Moorebank Precinct West - Stage 3

Response to Submissions -
(SSD 10431)

Moorebank Precinct West Stage 3 Response to Submissions Report – SSD 10431

Figure 4-1: Figure R44.2(a) from RMS' Guide to QA Specification R44 Earthworks

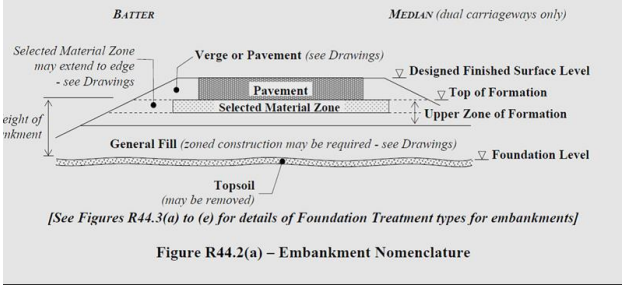
Construction	Fill importation	<p><u>Importation of fill to the MPW Stage 3 site</u></p> <p>The Submissions Report must clarify whether the proposed fill volumes are additional to those volumes assessed as part of SSD 5066 (MOD1) and SSD 7709. Further, the Submissions Report must provide a detailed response that demonstrates compliance with CoC 19B of SSD 5066 (as modified), which stipulates:</p> <p><i>the total volume of uncompacted fill to be imported must not exceed 1,600,000 m³ unless it can be demonstrated in a future Development Application that the proposed finished surface level of any filled section of the site does not exceed 16.6 m AHD.</i></p>	<p>In accordance with SSD 5066 MOD1 (30 October 2019) CoC 19B, 1,600,000 m³ uncompacted clean fill material may be imported to the site to achieve final site levels to meet the desired stormwater outcomes by providing for subsurface infrastructure that enables an east to west gradient for drainage to the onsite storage OSDs.</p> <p>To provide the structural integrity required to support approved site undertakings, appropriate compaction and stabilisation of imported fill material will be required. Compression of the approved 1,600,000 m³ uncompacted fill material will result in an ultimate surface level shortfall to achieve modelled site stormwater design requirements to achieve finished site surface levels. The Proposal includes the importation (from offsite locations) of approximately 280,000 m³ of unconsolidated clean fill for compaction up to final land surface level and</p>	<p><u>RtS:</u> This table Appendix G</p> <p><u>EIS:</u> Section 3.1.1.2</p>

approximately 540,000 m³ of structural fill for warehouse pad completion, in addition to the imported fill approved under SSD 5066 MOD1 (refer to Figure 4-1).
